GEORGE HALL MPR AND SUPPORT ROOMS PROJECT #19-143

ADDENDUM NO. 2

Date: November 19, 2021

Project: #19-143 George Hall MPR and Support Rooms Project
DSA #: 01-119574 41-26

4 PACKAGE 2 STAGE HEAT PUMP UNIT CONTROL DIAGRAM
SCALE: 1/8" = 1'-0"

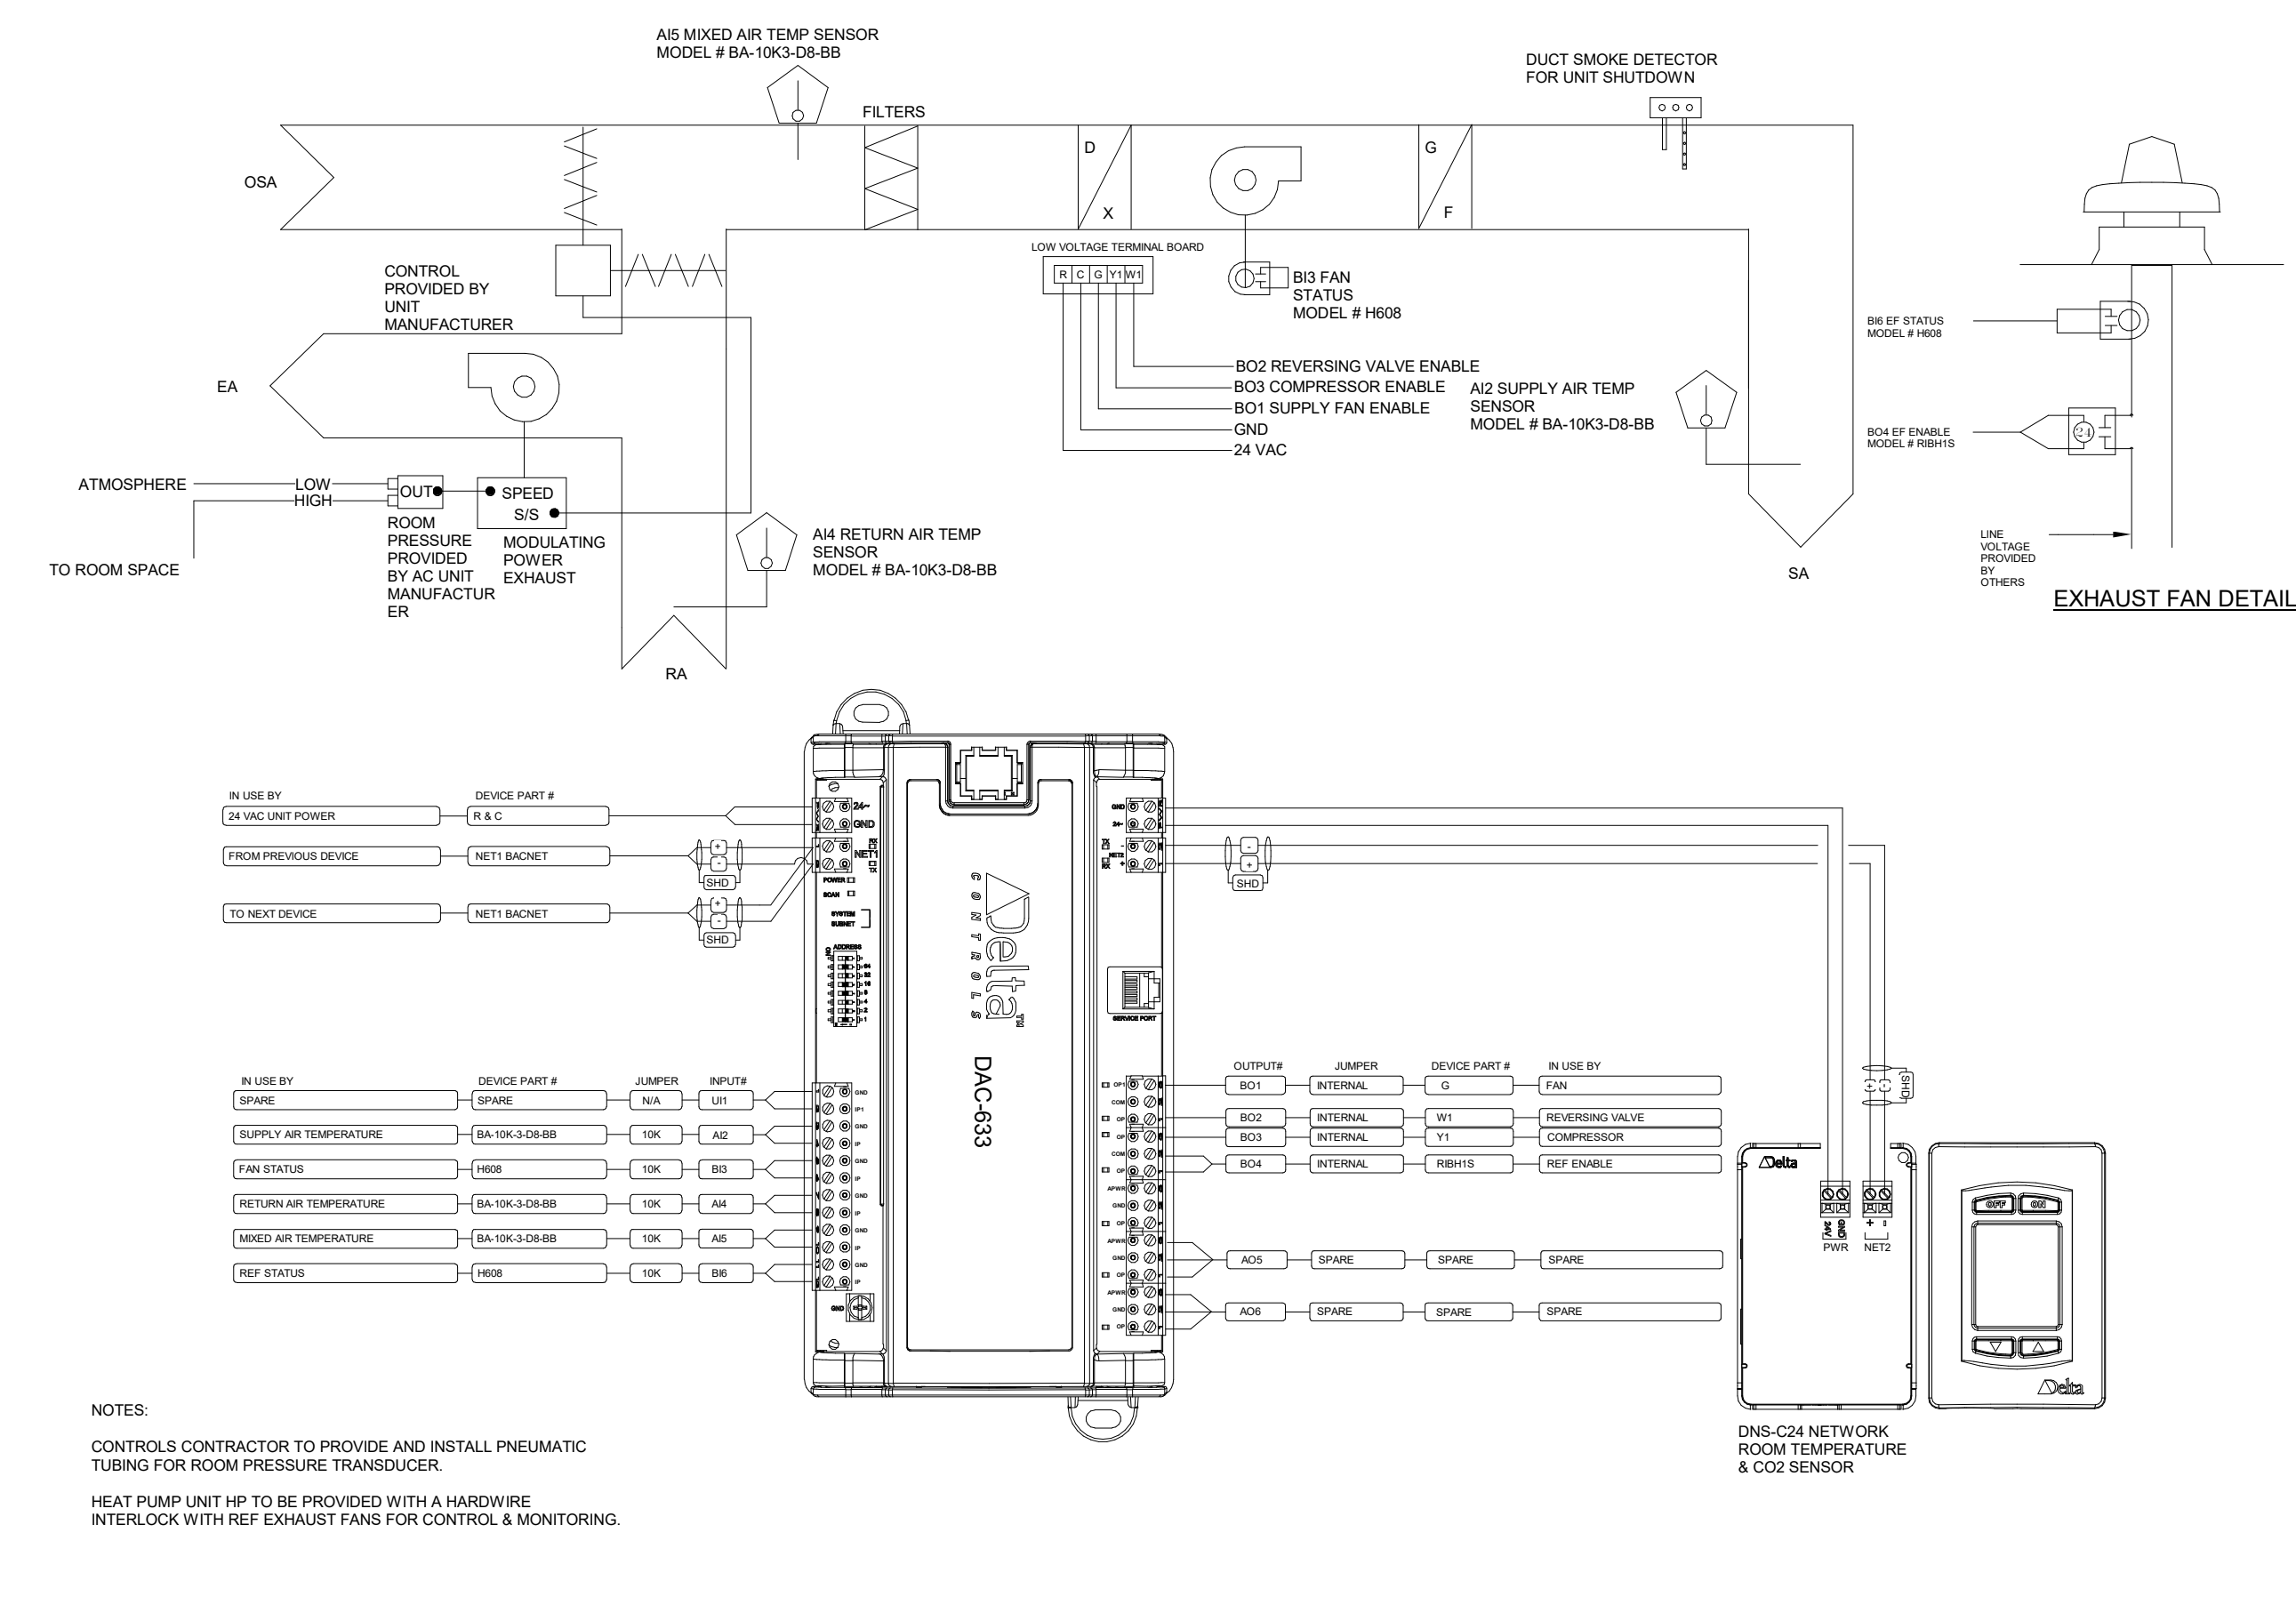
- A. Revised Mechanical Controls.
